Ref. No.: TSTY/VC/2025/0408/001

Project: Transformer

Subject: Clarification

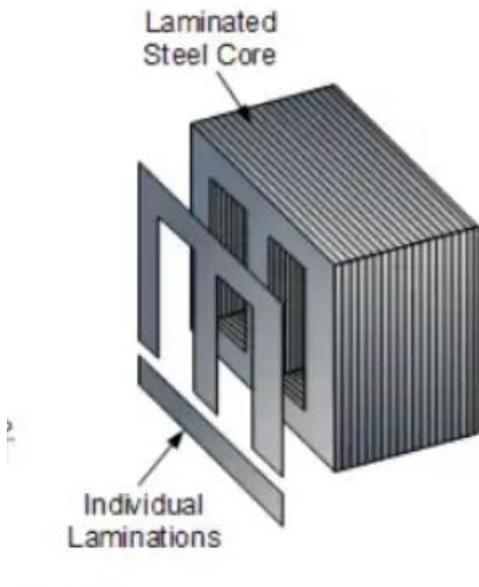
3. The shape and type of the coils.

Reply: see below photo
